1550 N. PROSPECT, MILWAUKEE

MINOR MODIFICATION AMENDMENT EXHIBITS 01-04 / 2023

Minor Modification to PD

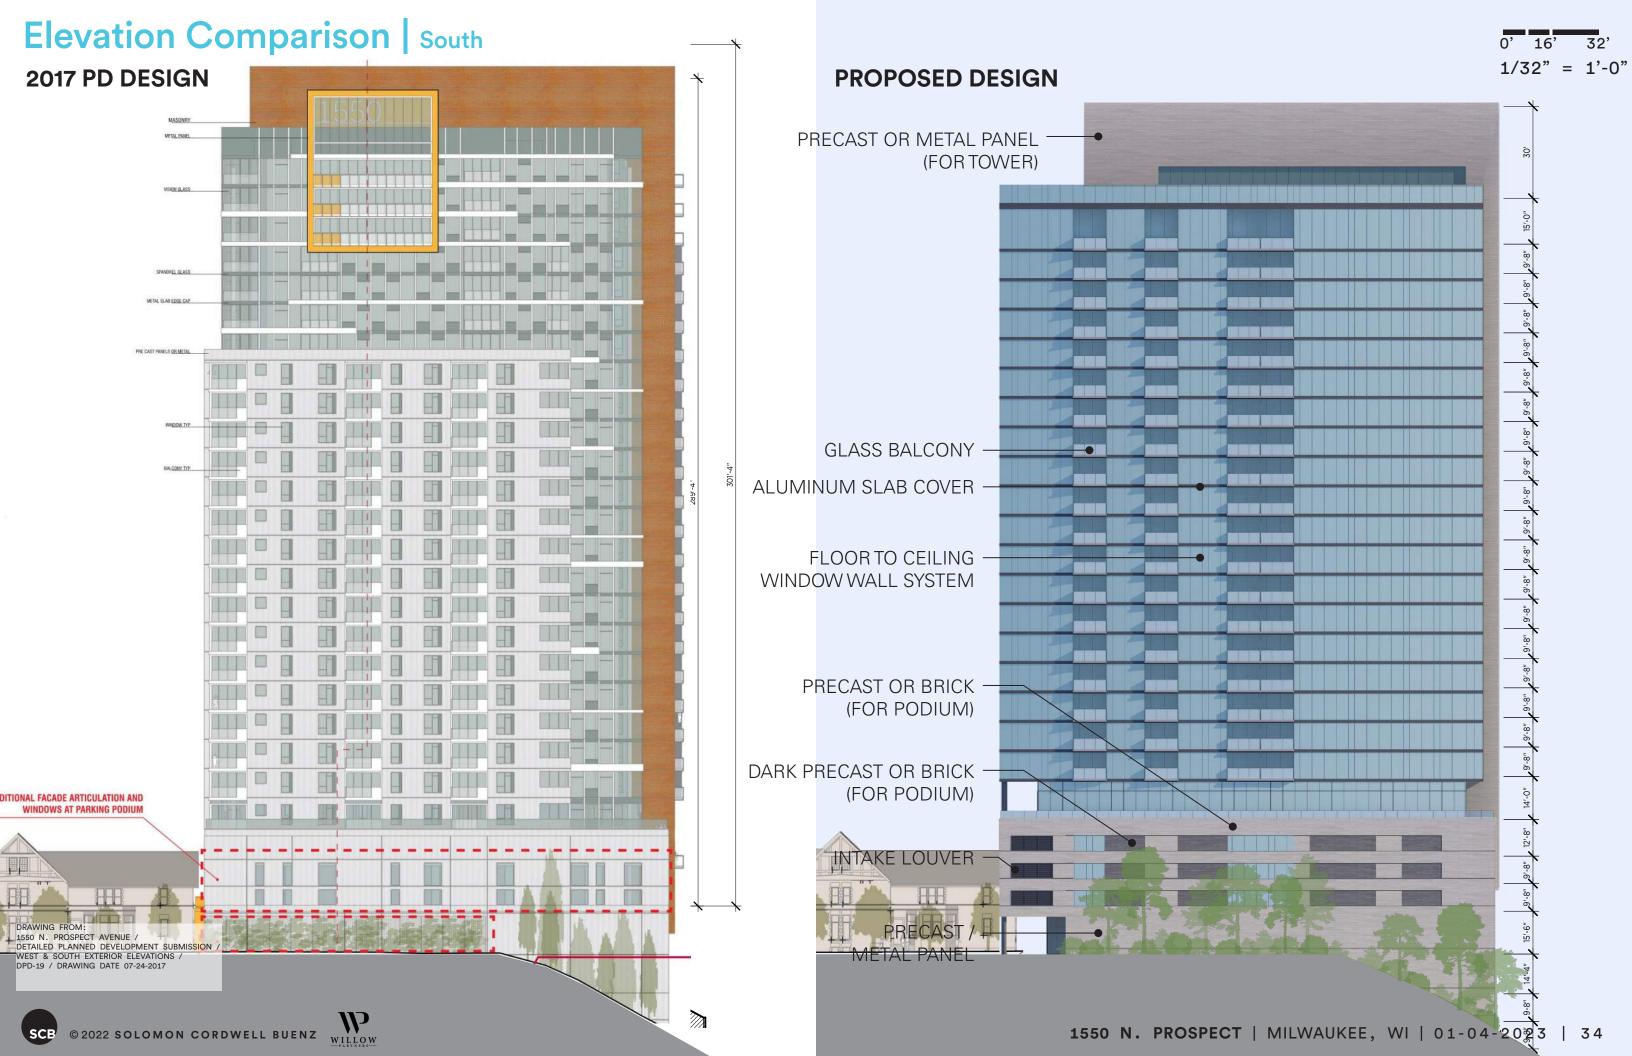
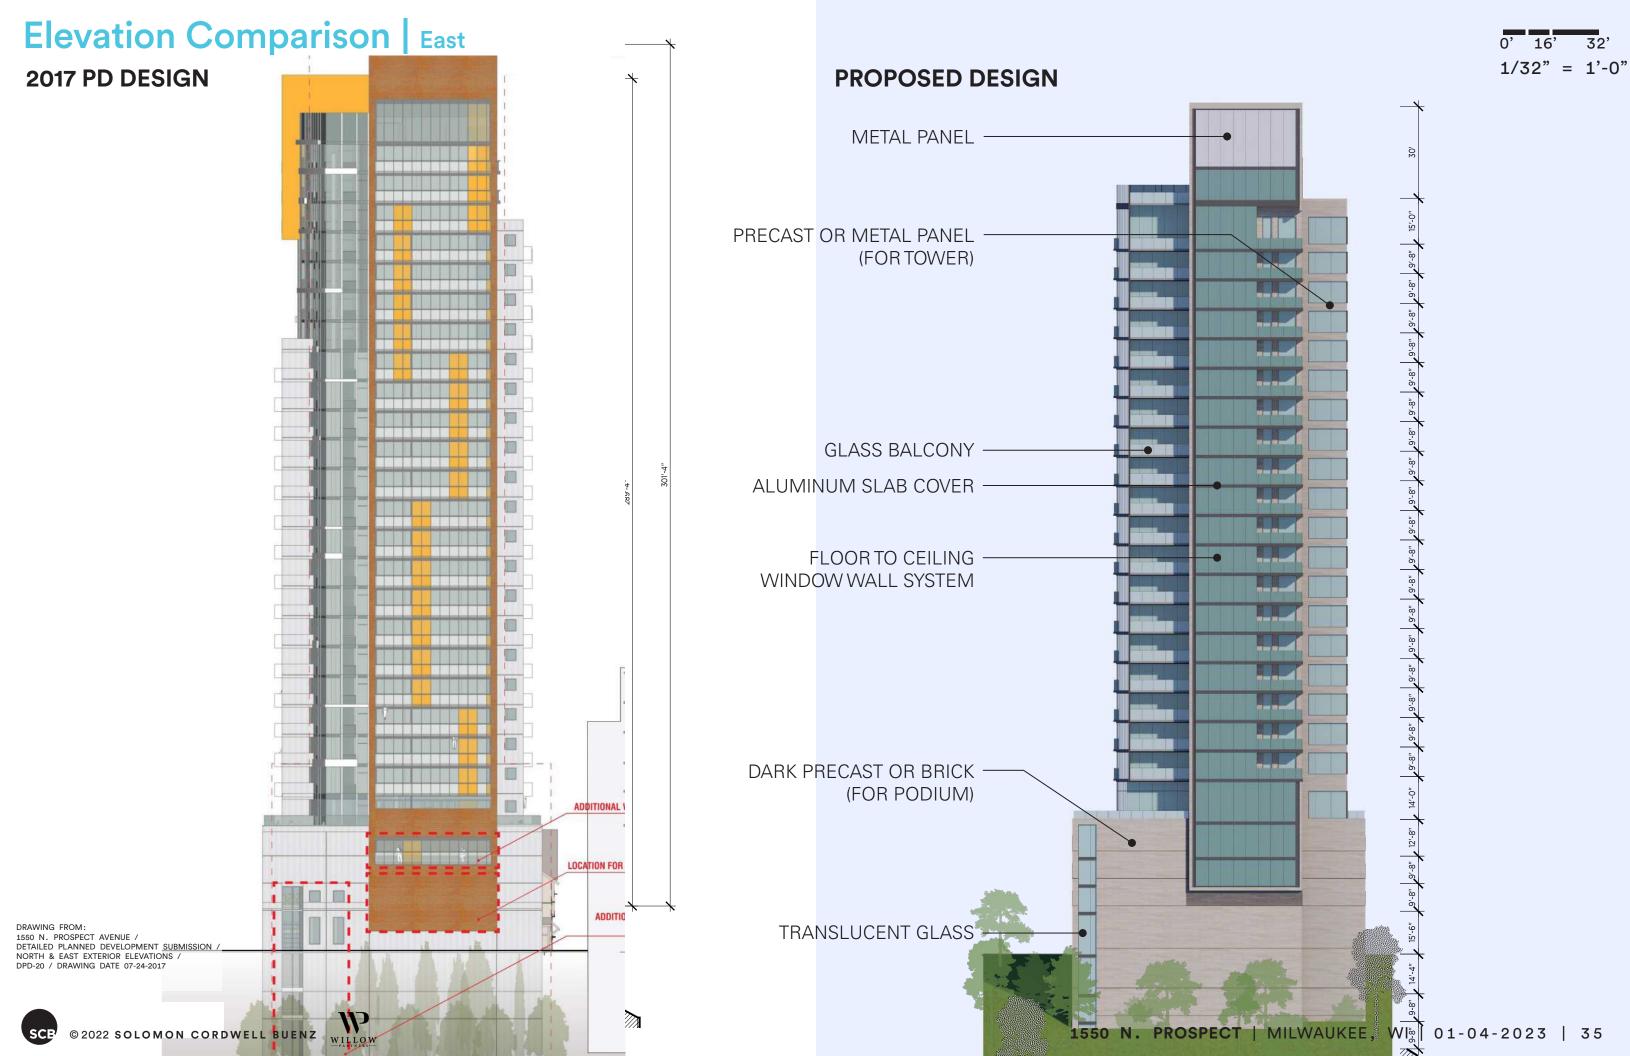
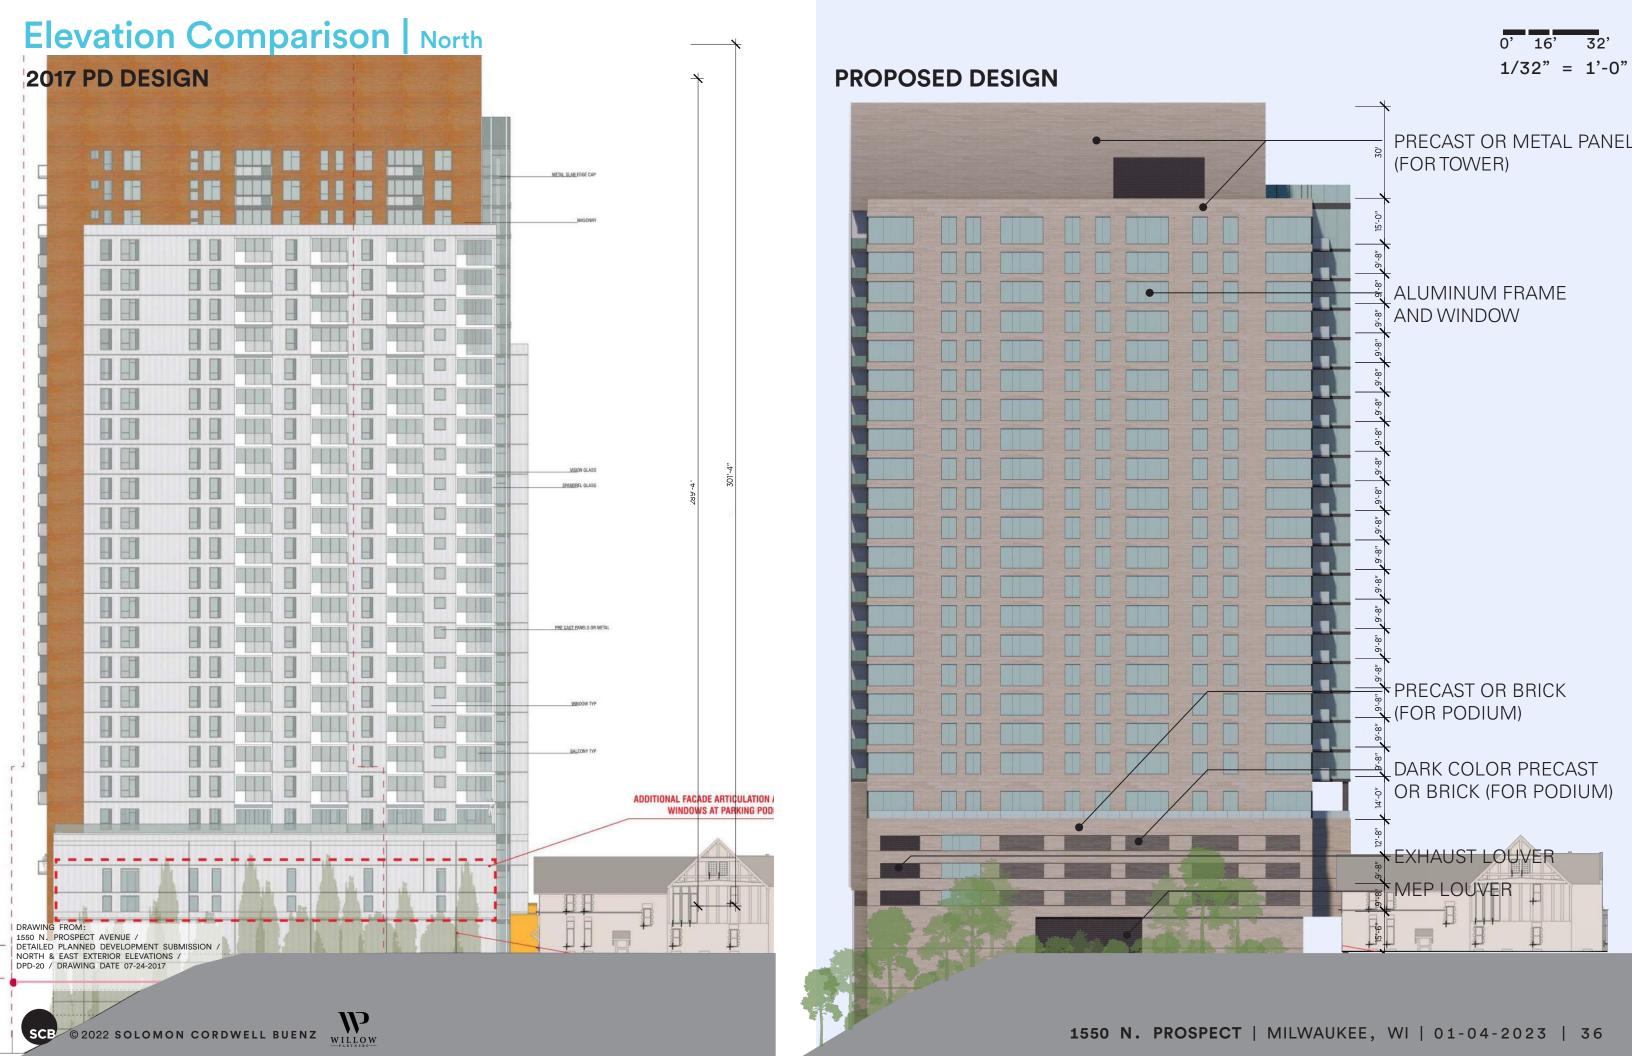
Elevation Comparison | west 2017 PD DESIGN **PROPOSED DESIGN** PRECAST OR METAL PANEL (FOR TOWER) ALUMINUM FRAME AND WINDOW GLASS BALCONY -**ALUMINUM SLAB COVER** FLOOR TO CEILING WINDOW WALL SYSTEM PRECAST OR BRICK (FOR PODIUM) GOLL HOUSE PROFILE BOUNDARY STOREFRONT GLASS 1550 METAL PANEL DRAWING FROM:
1550 N. PROSPECT AVENUE /
DETAILED PLANNED DEVELOPMENT SUBMISSION.
WEST & SOUTH EXTERIOR ELEVATIONS /
DPD-19 / DRAWING DATE 07-24-2017 © 2022 SOLOMON CORDWELL BUENZ WILLOW

#1 Proposed design maintains

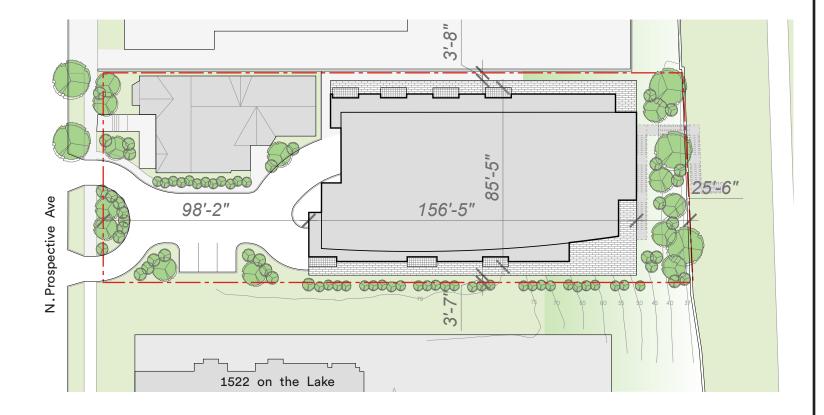
the general character of the approved PD design

#3 Proposed design maintains

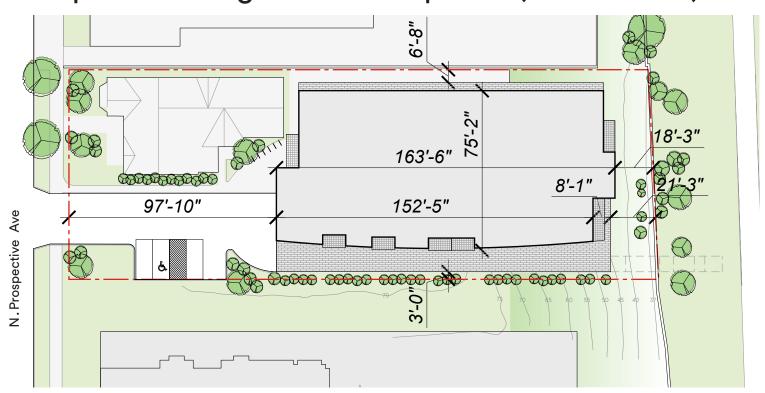
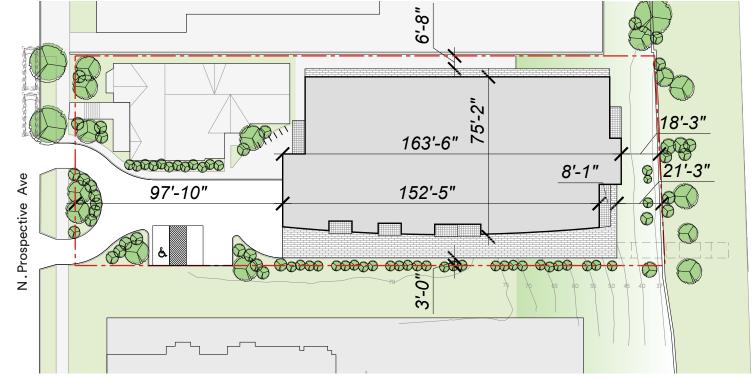
the location and size of parking, loading and recreation areas relative to the approved PD design

Proposed design - base option (1 curb cut)

Proposed design - alt option (2 curbs cut)

#4 Proposed design maintains

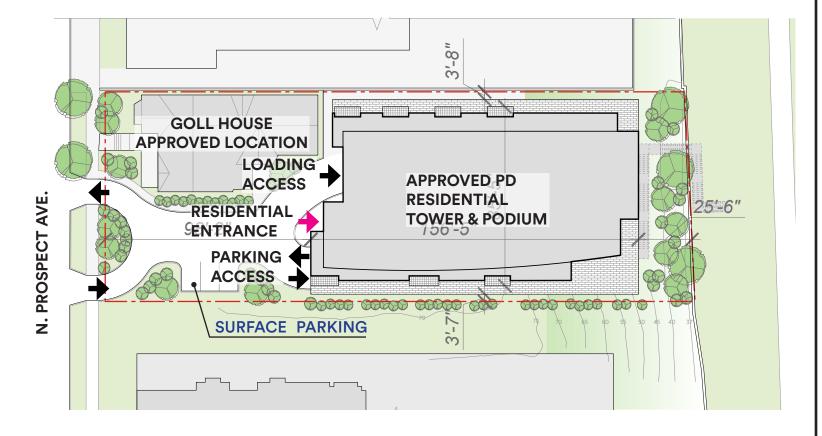
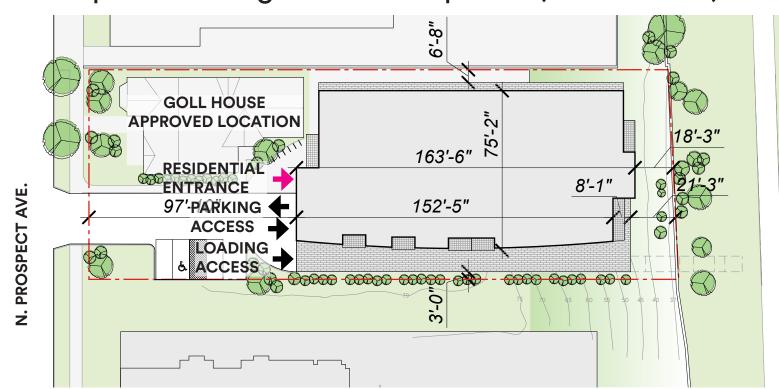
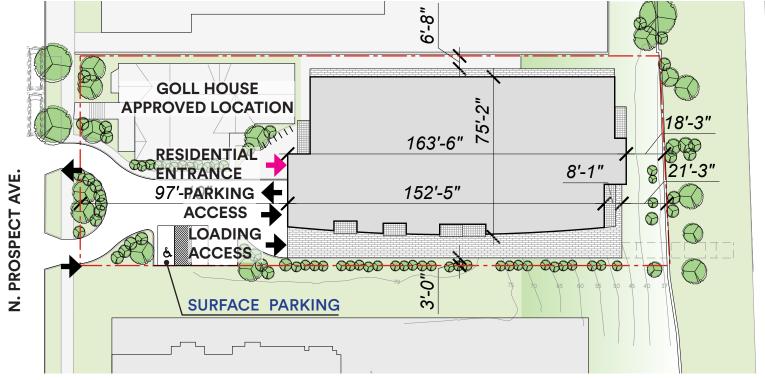
the location of traffic facilities relative to the approved PD design

Proposed design - base option (1 curb cut)

Proposed design - alt option (2 curbs cut)

#5 Proposed design maintains

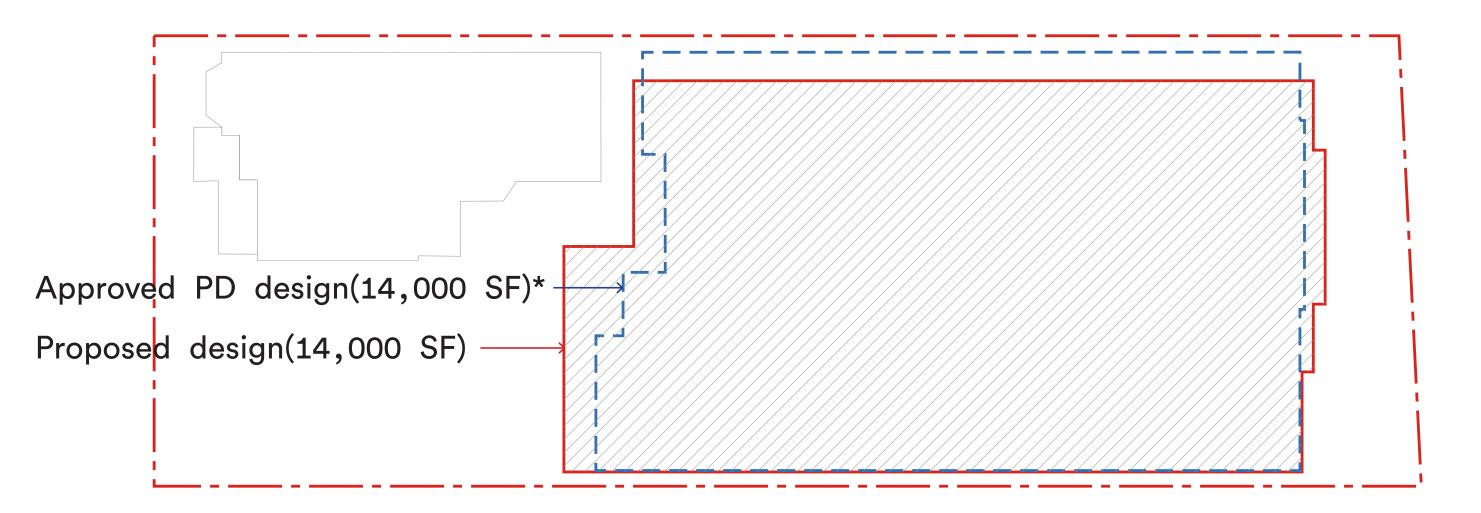
the land coverage by buildings and parking areas from the approved PD design

#6 Proposed design reduces

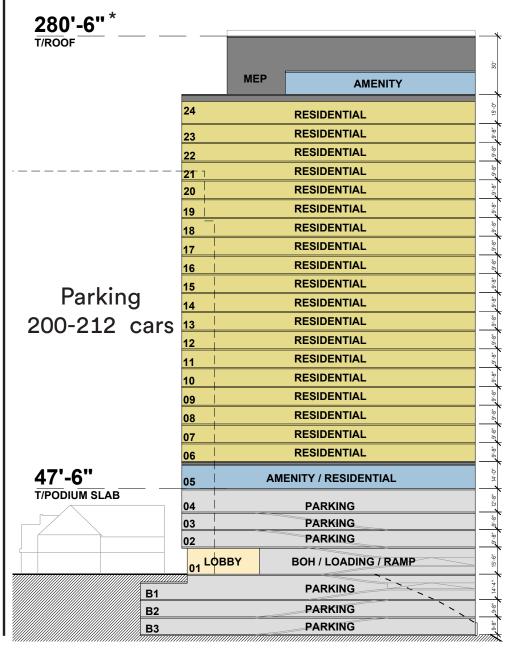
the gross floor area of the buildings from the approved PD design

RESIDENTIAL GSF: 270,000 sf PARKING GSF: 100,000 sf

> RESIDENTIAL GSF: 256,000 sf PARKING GSF: 93,000 sf

RESIDENTIAL GSF: 256,000 sf PARKING GSF: 100,000 sf

#7 Proposed design maintains

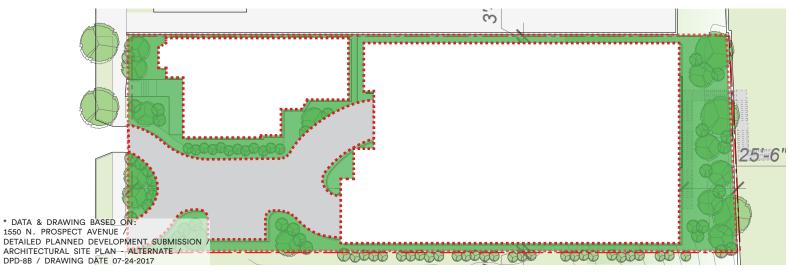
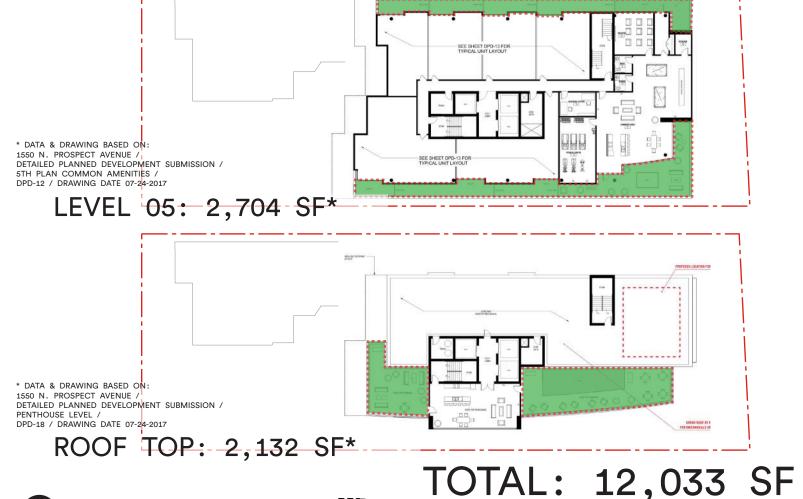
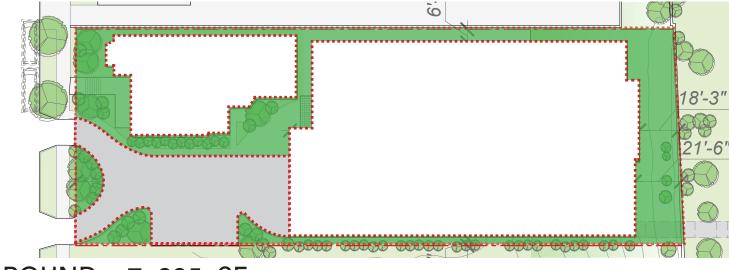
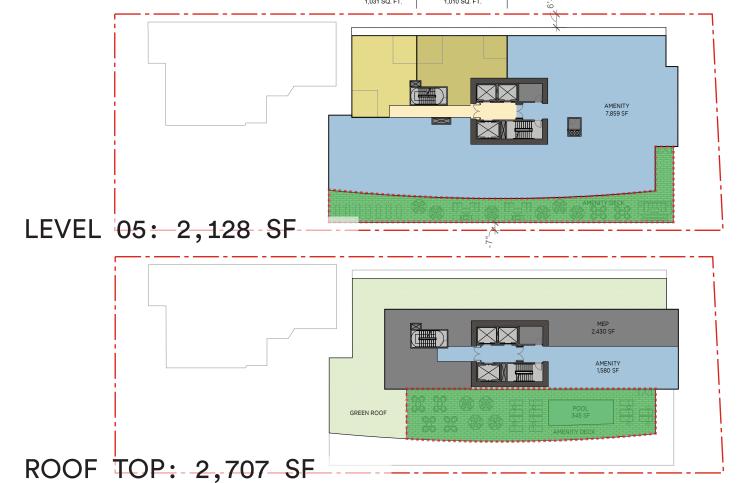
the amount of open spaces, landscaping and screening from the approved PD design

GROUND: 7,197 SF*

GROUND: 7,205 SF
